**TOWN OF NEWBURGH
PLANNING BOARD
TECHNICAL REVIEW COMMENTS**

PROJECT: CORTLAND COMMONS
PROJECT NO.: 2017-11
PROJECT LOCATION: SECTION 9, BLOCK 1, LOT 60
REVIEW DATE: 28 JULY 2017
MEETING DATE: 3 AUGUST 2017
PROJECT REPRESENTATIVE: JMC PLANNING & ENGINEERING

Response to MH & E "Town of Newburgh Planning Board Technical Review Comments", dated 03/16/2017

33

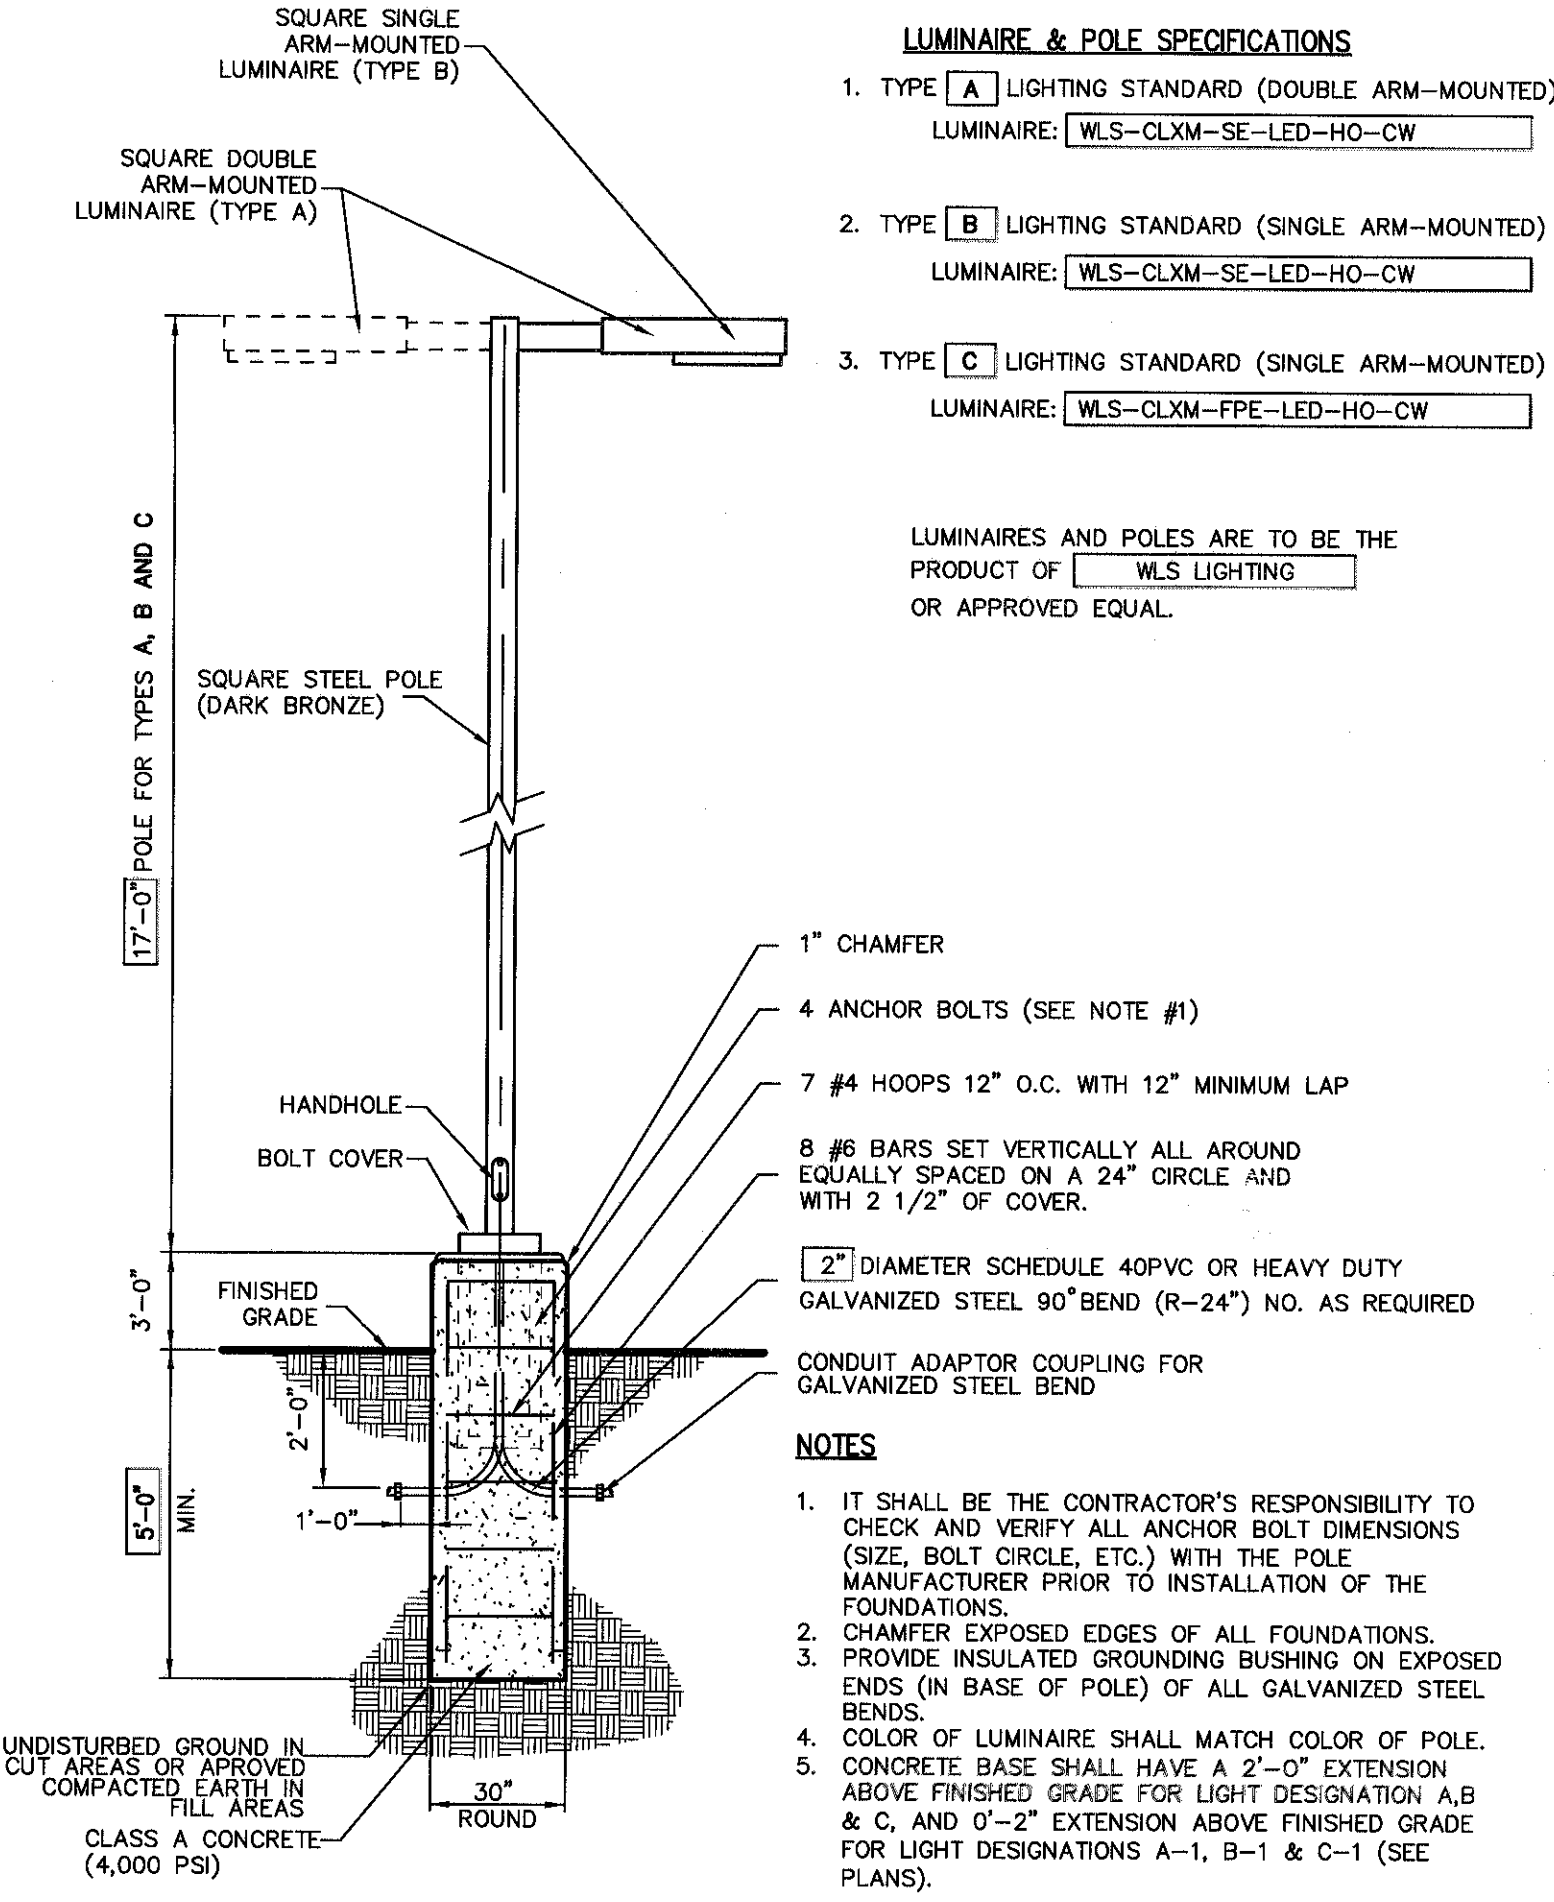
9. The Planning Board's attention is called to the use of concrete bumper blocks on the south west portion of the fast food restaurant and retail building. The Applicant's representative is asked to discuss the transition between the concrete curb and the at grade sidewalk on the south west portion of the retail building.

ENTERING FROM 9W AND
EXITING TO CORTLAND DRIVE
SCALE: 1" = 30'

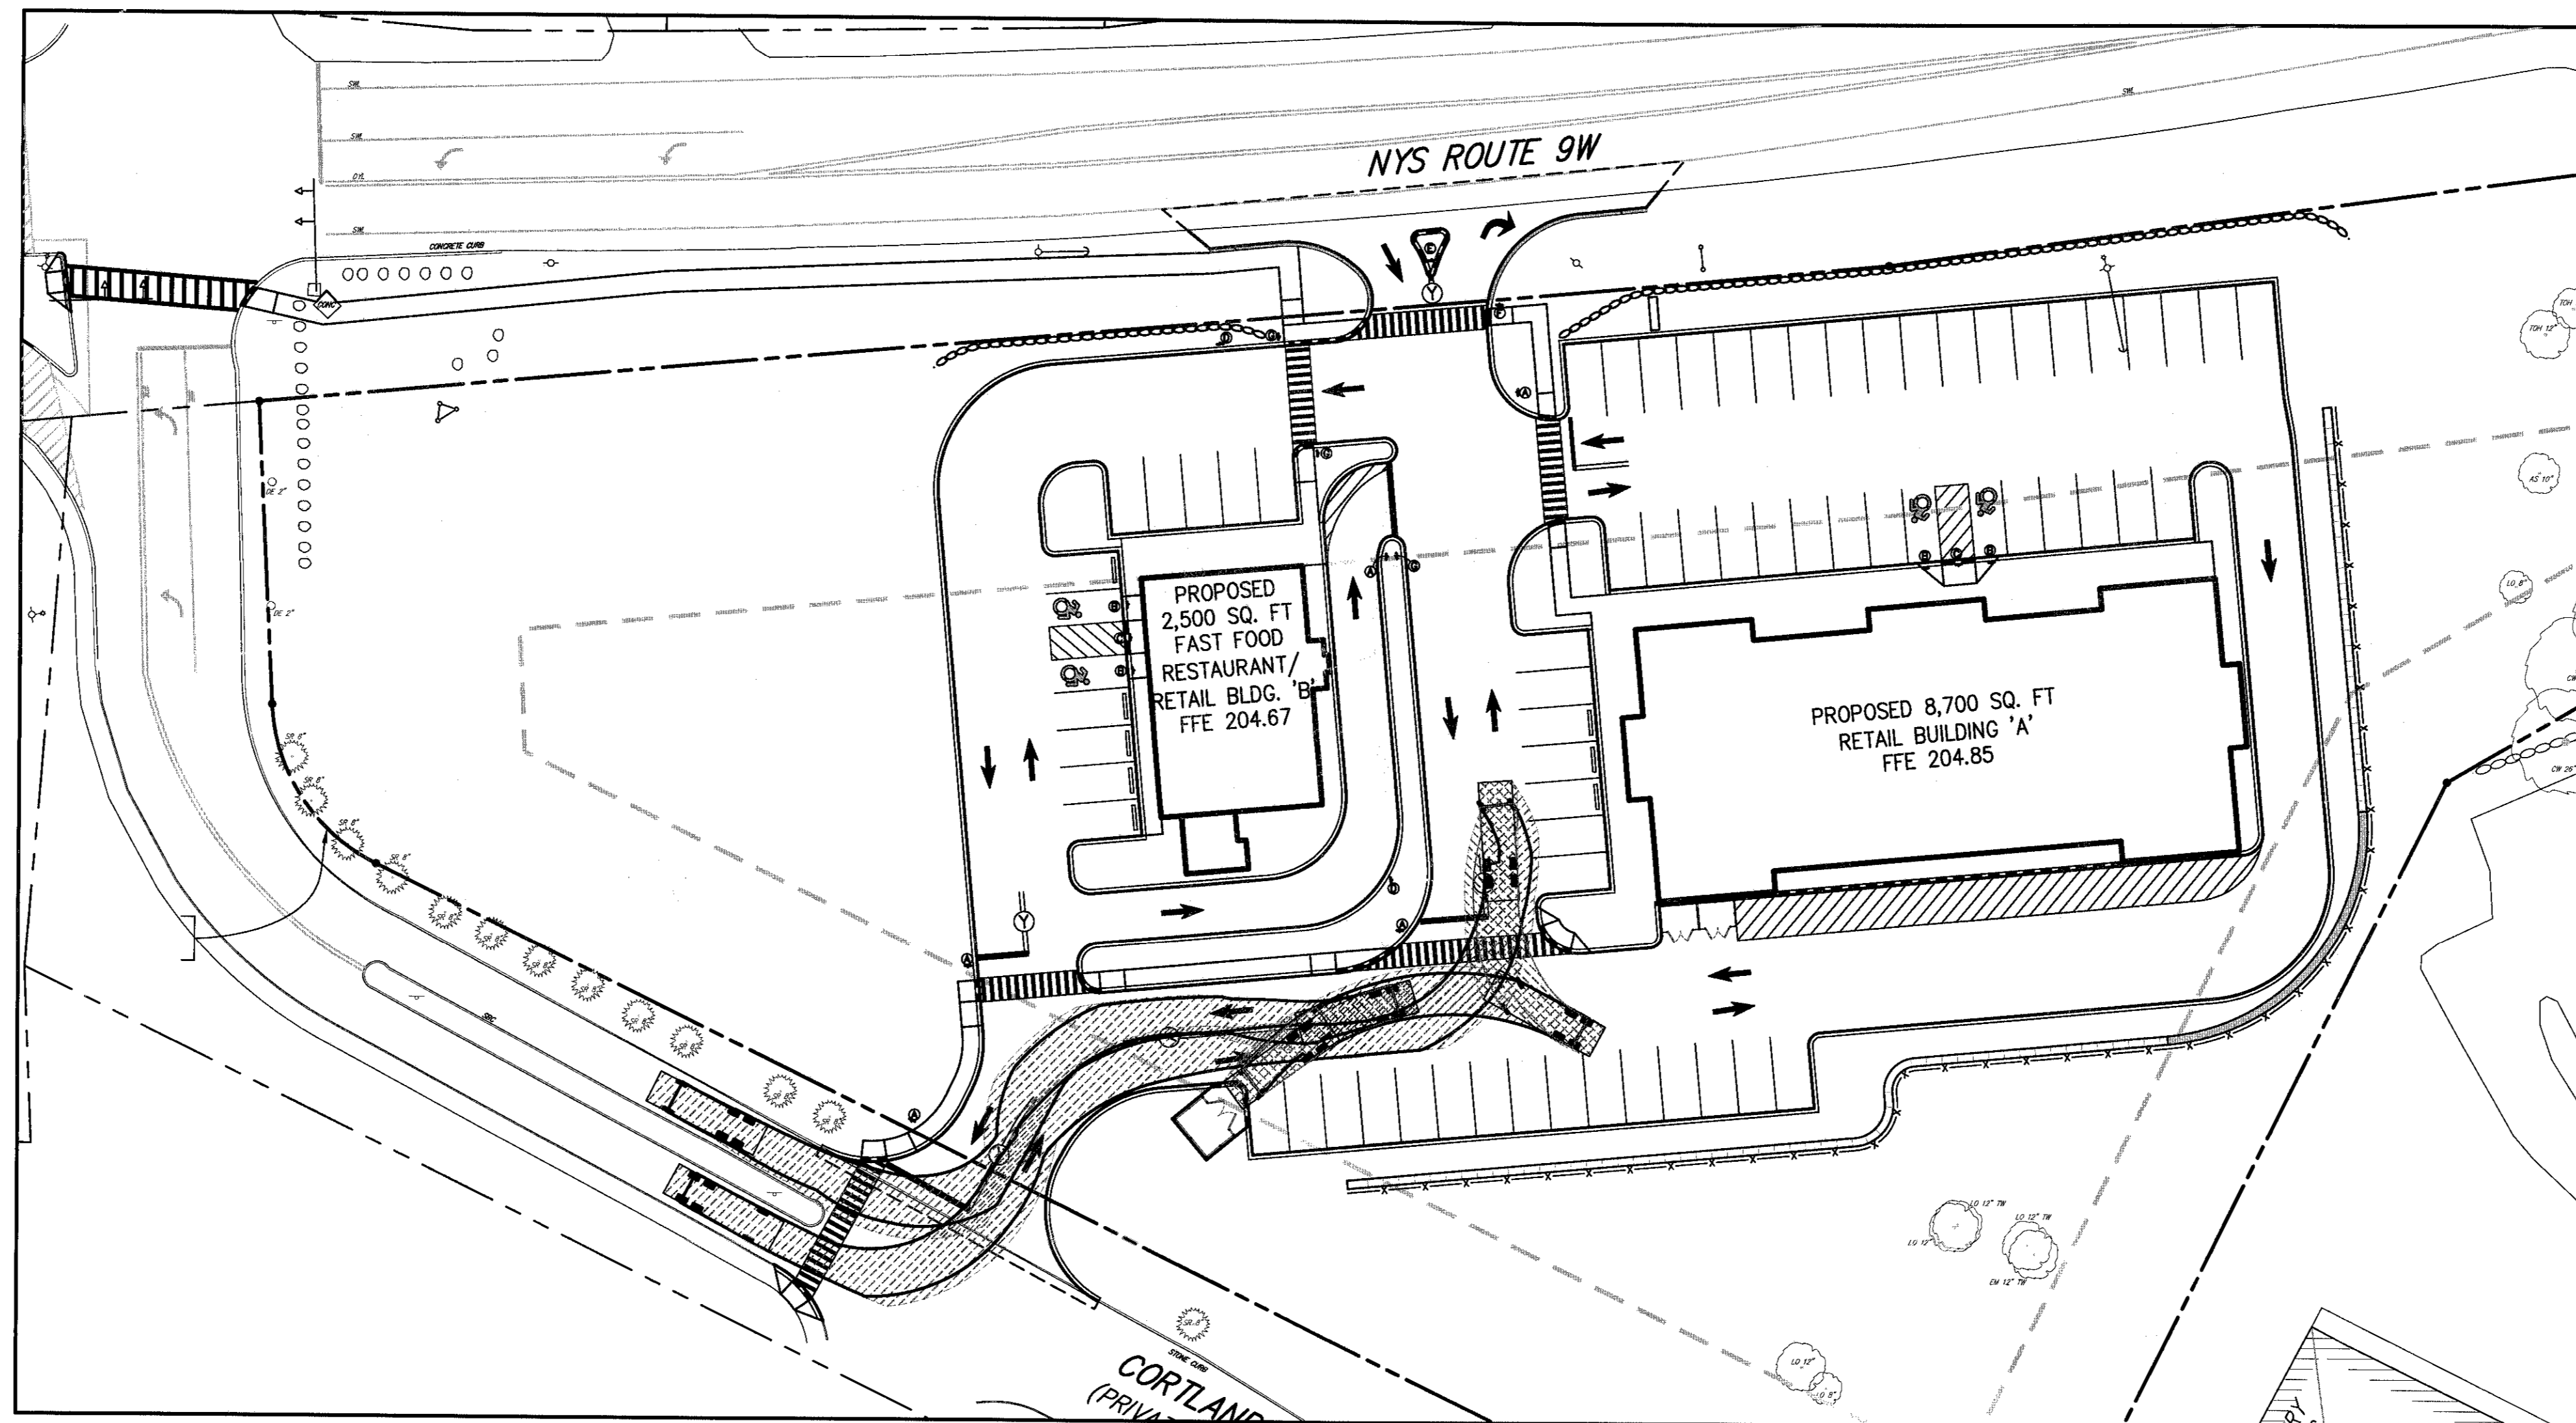
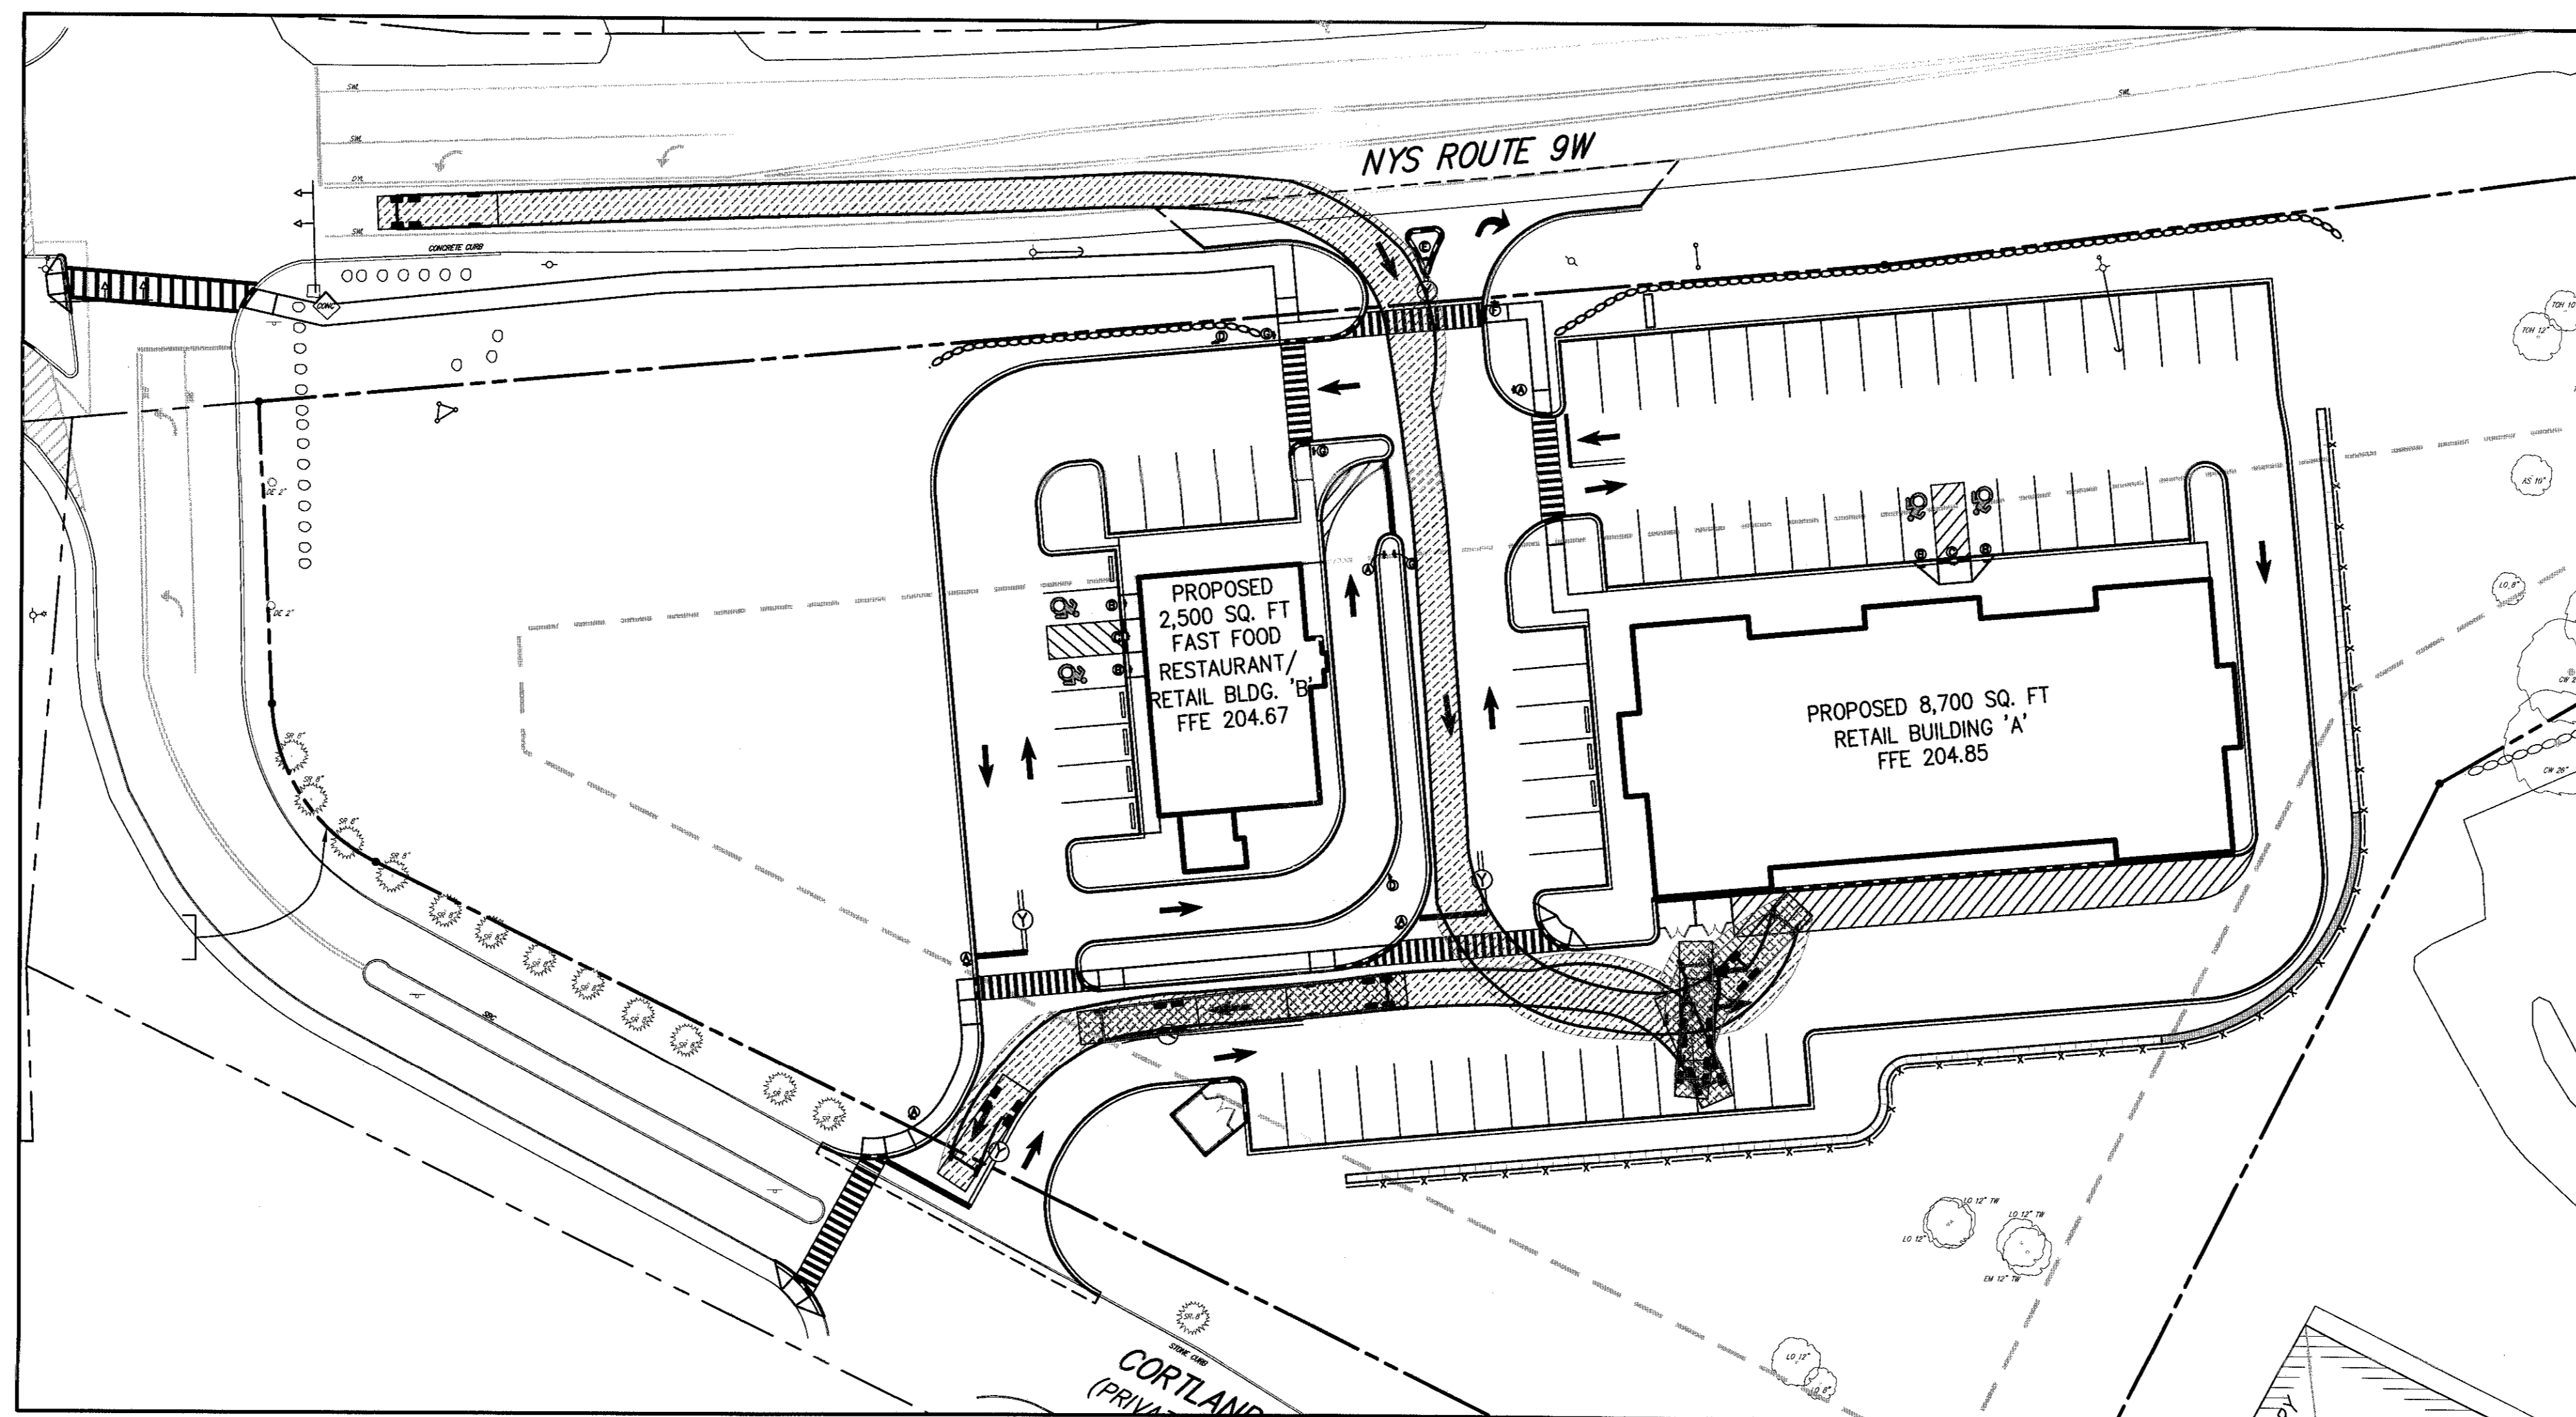
The garbage enclosure orientation may limit the ability for a front lift truck to access the dumpsters. A truck circulation plan should be prepared in future submissions.

SP-15 Truck Access Plan has been added to the drawing set to illustrate garbage truck turning maneuvers. The garbage enclosure locations have been modified to improve accessibility.
